MEMORANDUM

To: Kathleen Smith, City of Haverhill
 From:  William G. Cunniff - Joslin, Lesser + Associates, Inc.
 Date: January 26, 2016
 Re: Construction Contingency Approval: Caleb Dustin Hunking School
 Cc: James F. Scully; Jeffery Luxenberg; Adam Sniegocki

Work Changes Proposal Request

PROJECT *(Name and address):*
Caleb Dustin Hunking School
98 Winchester Street
Haverhill, MA 01835

DRAWING REFERENCE: SK-005

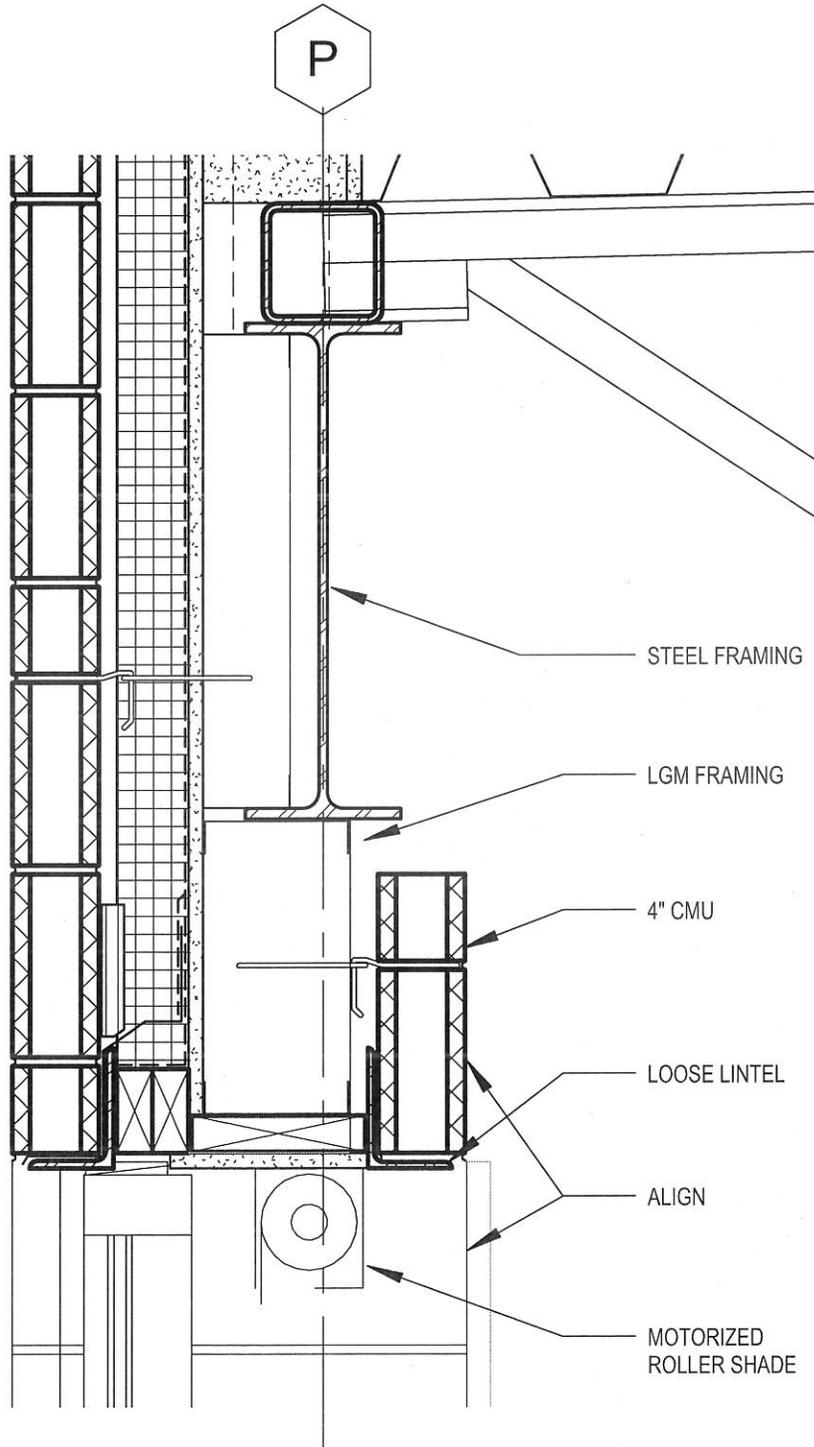
Where the depth of CMU coursing as prescribed by structural typical detail 7/S-003 is not attainable due to the limited dimension between the underside of roof steel beams and the top of masonry openings, delete the 12" CMU over the window and ADD LGMF framing. ADD 4" CMU veneer, supported by a loose lintel as scheduled on detail 12/S-004. Coordinate locations with ARCH dwgs and submit shop drawings for review by the design team prior to fabrication.

REFER TO 1/A-321

Request for Information RFI216

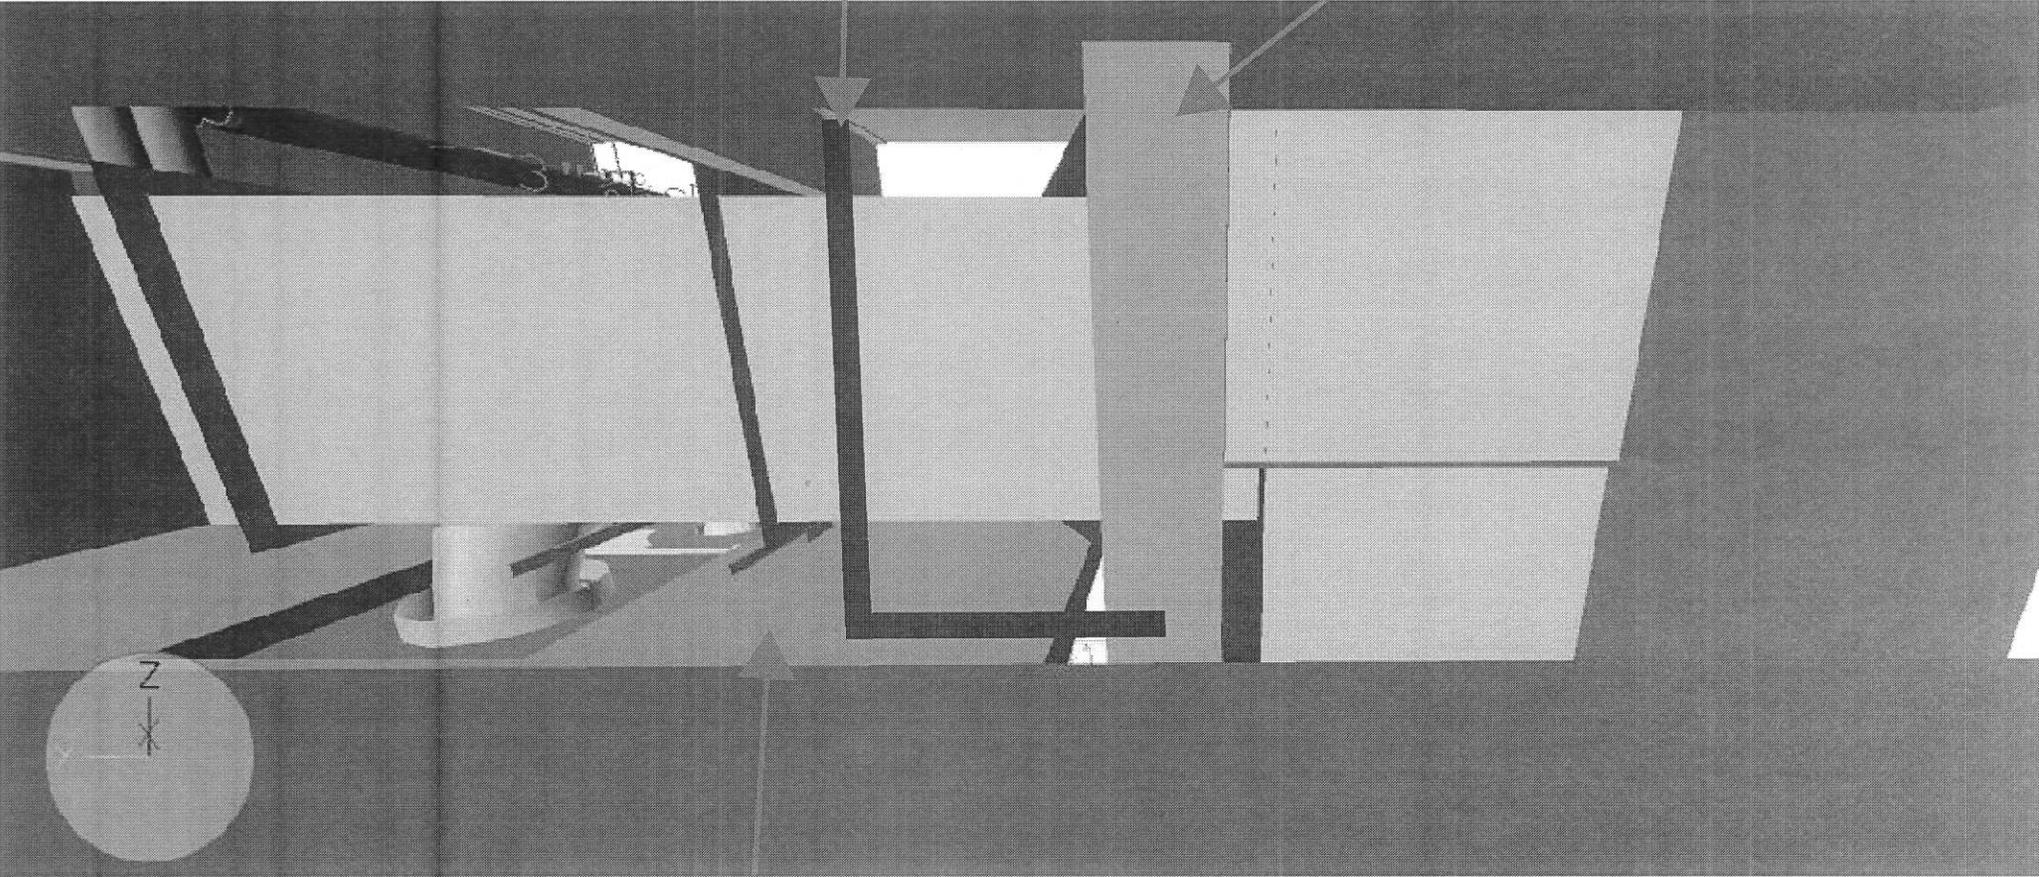
Please see the attached marked up, 3D coordination drawings. The duct shaft to the east of bathrooms A208 and A308 calls for a fire damper to be installed where the duct penetrates the duct shaft wall. Due to the clearance needed by the fire damper, it will be installed outside of the shaft wall currently shown on the drawings.

In order to keep the fire damper within the fire rated shaft, a fire rated soffit will need to be installed to enclose the fire damper within the shaft. This fire rated soffit will have a horizontal segment that extends above the ceiling and a vertical segment that rises up the the decking of the floor above (see attached sketch). This is being proposed on the second floor, west side of the duct shaft.

This solution, as discussed on site, is acceptable. Verify as-built shaft dimensions. Soffit depth determined by depth required for fire damper and should be held tight to sides of duct. KKL 11/25/15

Request for Information RFI216

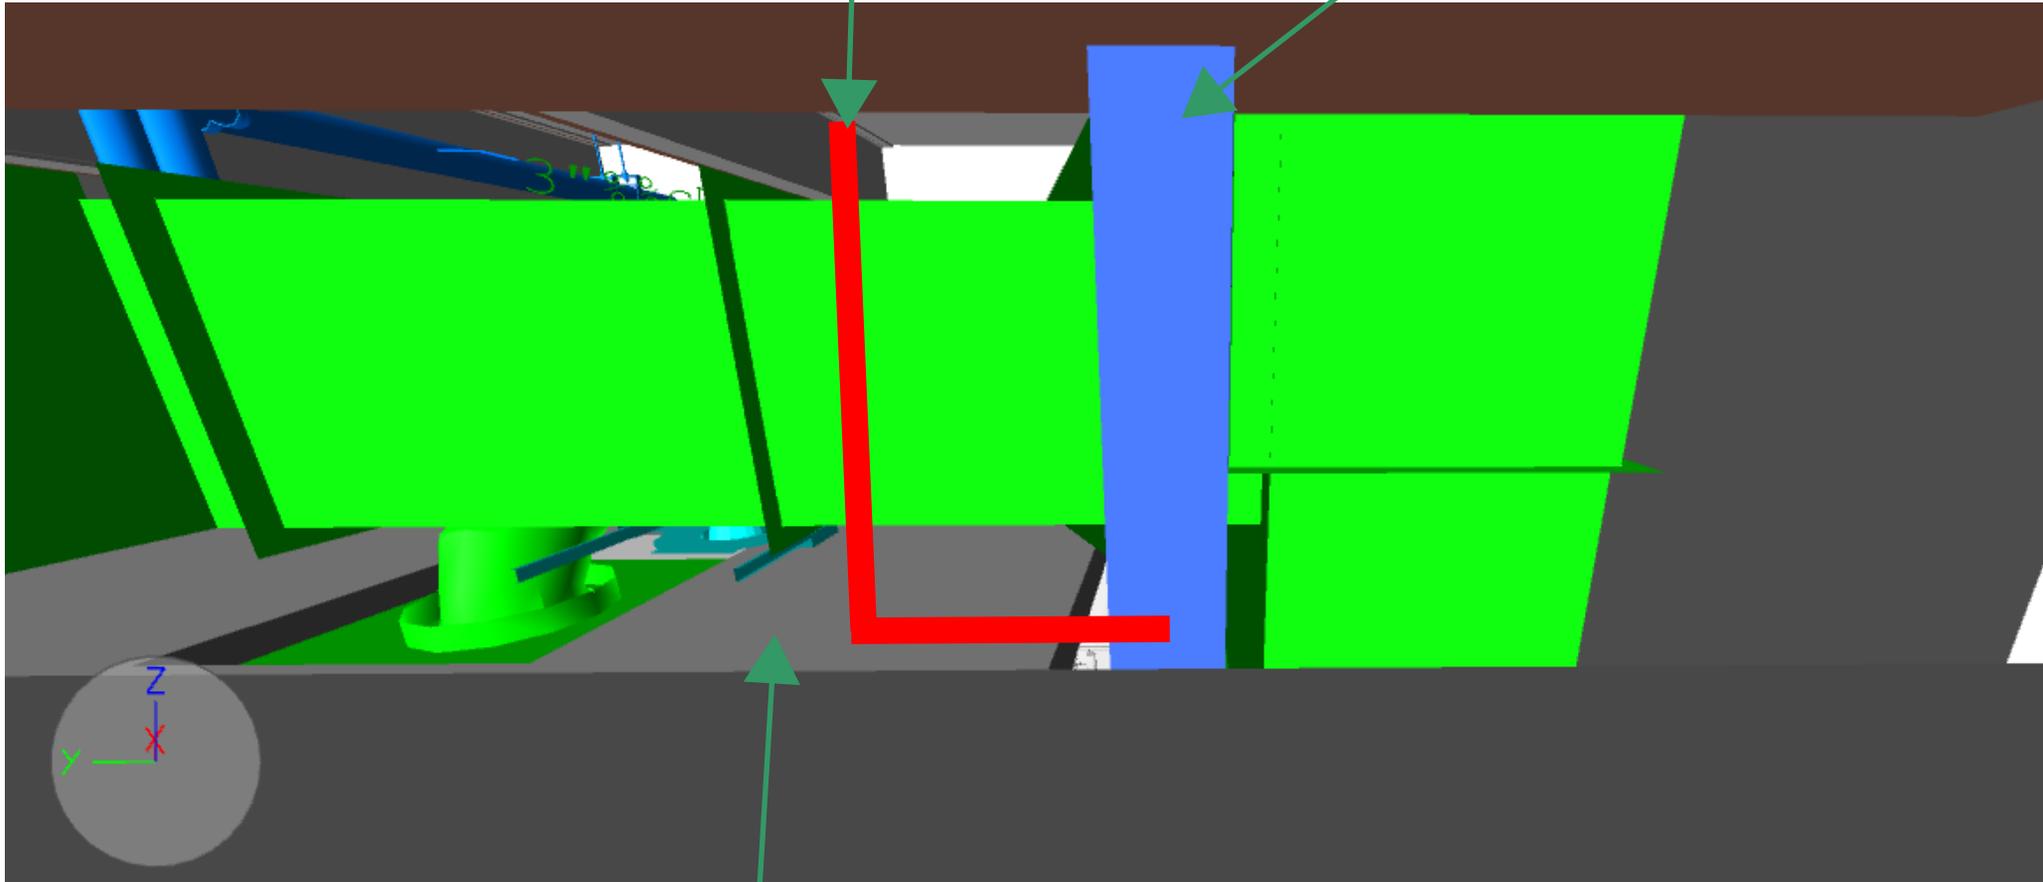
Please see the attached marked up, 3D coordination drawings. The duct shaft to the east of bathrooms A208 and A308 calls for a fire damper to be installed where the duct penetrates the duct shaft wall.

In order to keep the fire damper within the fire rated shaft, a fire rated soffit will need to be installed to enclose the fire damper within the shaft. This fire rated soffit will have a horizontal segment that extends above the ceiling and a vertical segment that rises up the the decking of the floor above (see attached sketch).

This solution, as discussed on site, is acceptable. Verify as-built shaft dimensions. Soffit depth determined by depth required for fire damper and should be held tight to sides of duct. KKL 11/25/15

FIRST FLOOR AREA B- LIGHTING
REVISIONS

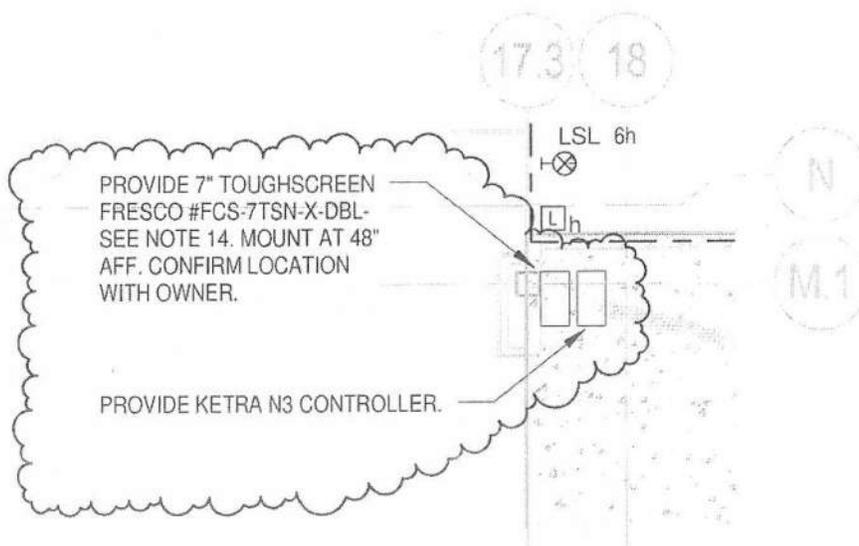
Provide proposal for theatrical lighting as described in the attached sketches.

14. PROVIDE FACTORY START-UP FOR PERFORMANCE LIGHTING & OWNER TRAINING. SUBMIT SHOP DRAWINGS OF ALL EQUIPMENT INCLUDING INTEGRATED SYSTEM SCHEMATIC.
